LOCAL HISTORIC DISTRICT APPLICATION FOR A CERTIFICATE OF APPROPRIATENESS

STAFF REPORT

COA: 17-049

Window changes, new doors, siding change & fence

Pinehurst Pizza

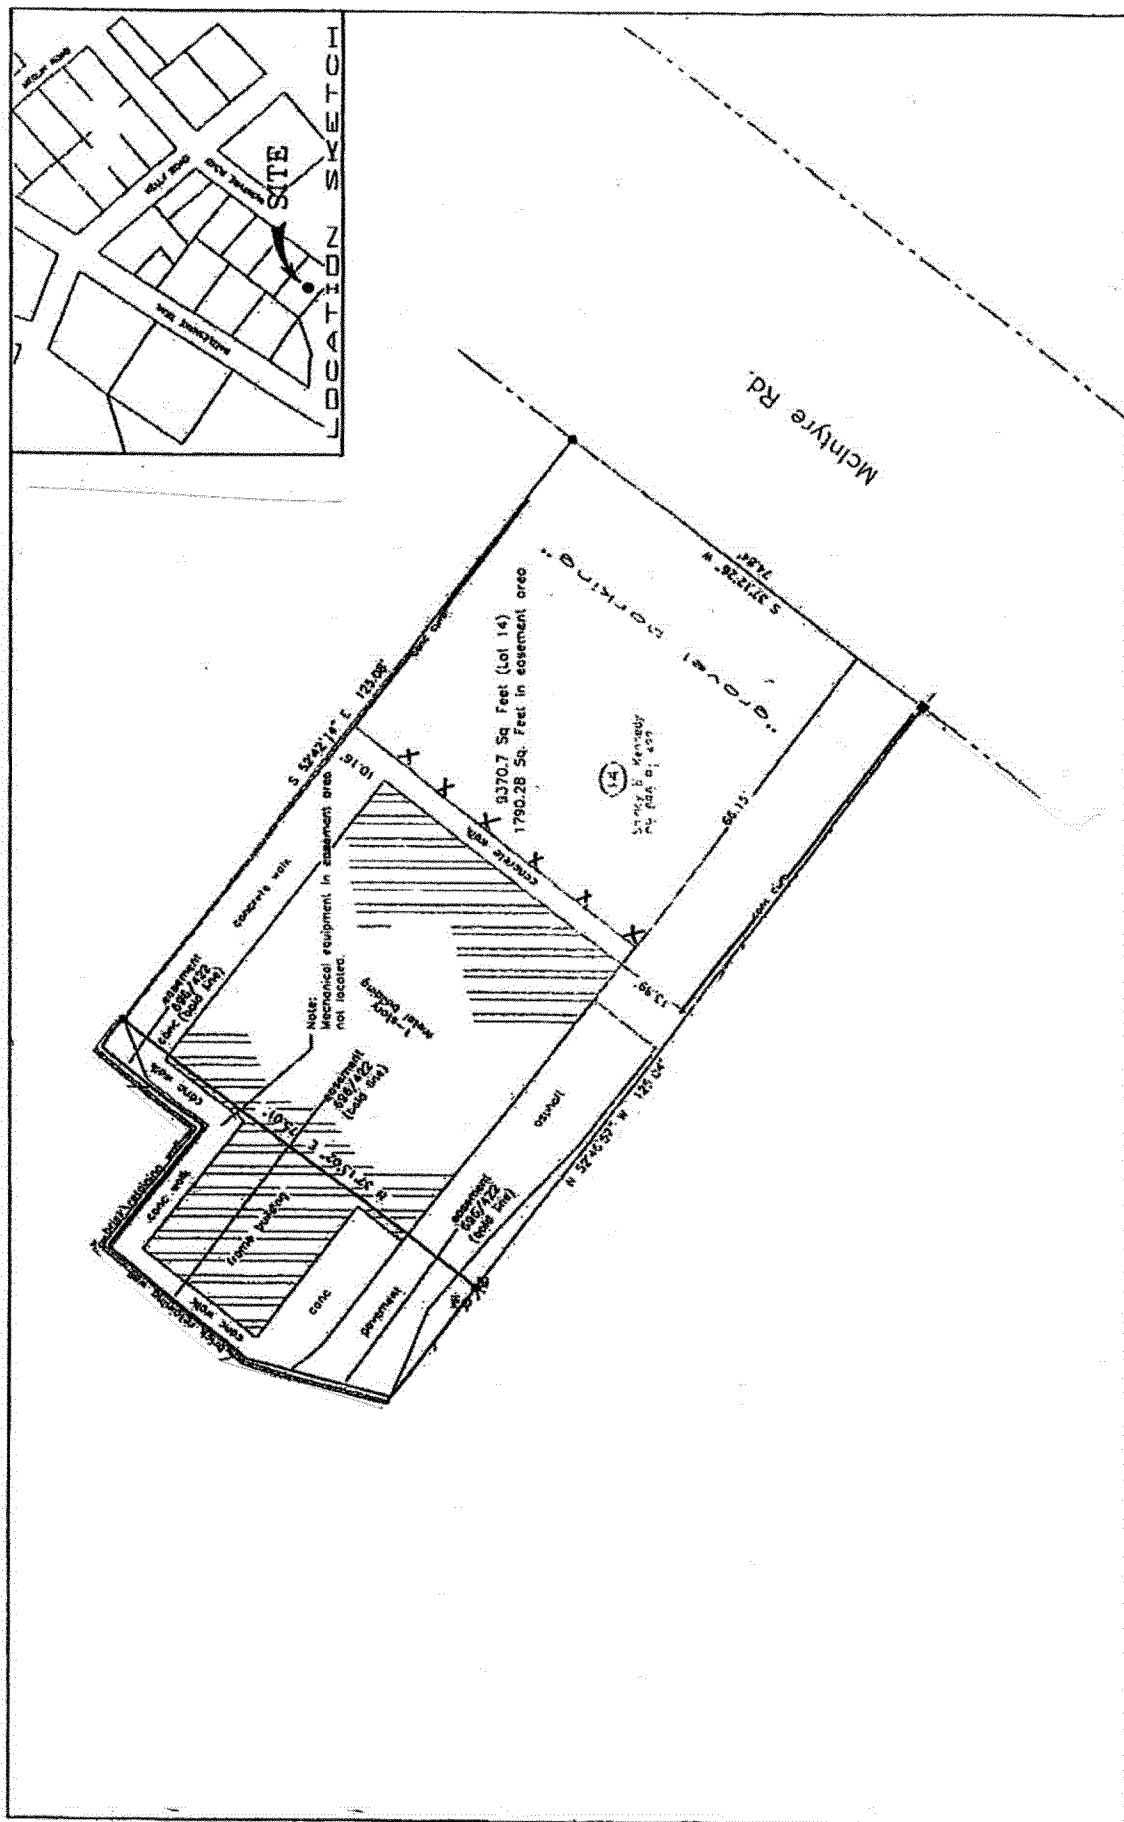
NEW WINDOWS & DOORS:

B. SECTION 2.4.2.1 WINDOWS AND DOORS STANDARDS – *Adding or changing original window and door openings shall not be permitted on the principal façade. If new uses for the structure require an additional door or a window, these shall be located where they are not visible from a principal street;*

1. The proposed new window openings **will/will not** be visible from the street.

C. SECTION 2.4.2.2 WINDOWS AND DOORS STANDARDS – *Windows and doors of existing buildings shall retain their original size and dimension;*

1. The proposed new windows for the building **will/will not** retain their original size and dimension.
2. The proposed new doors for the building **will/will not** retain their original size and dimension.

NEW SIDING:

F. SECTION 2.2.2.3 MASONRY STANDARDS – *If replacement of a large masonry surface or entire feature is necessary, replace it in kind, matching the original in design, detail, dimension, color, pattern, texture, and material. Consider compatible substitute materials only if the original material is not viable;*

1. The proposed new siding **does/does not** match the original siding in design, detail, dimension, color, pattern, texture and material.
2. The original material **is/is not** viable.

FENCE:

H. SECTION 2.17.1.5 FENCE GUIDELINES – *All fences and walls should be compatible with the architecture of the structure(s) on the property;*

1. The proposed fence **is/is not** compatible with the architecture of the structures on the property.

I. SECTION 2.17.1.8 FENCE GUIDELINES – *Fences over 3.5' in height shall be screened with native landscaping on sides visible from the street;*

1. The proposed fence **will/will not** be screened with native landscaping on sides visible from the street.
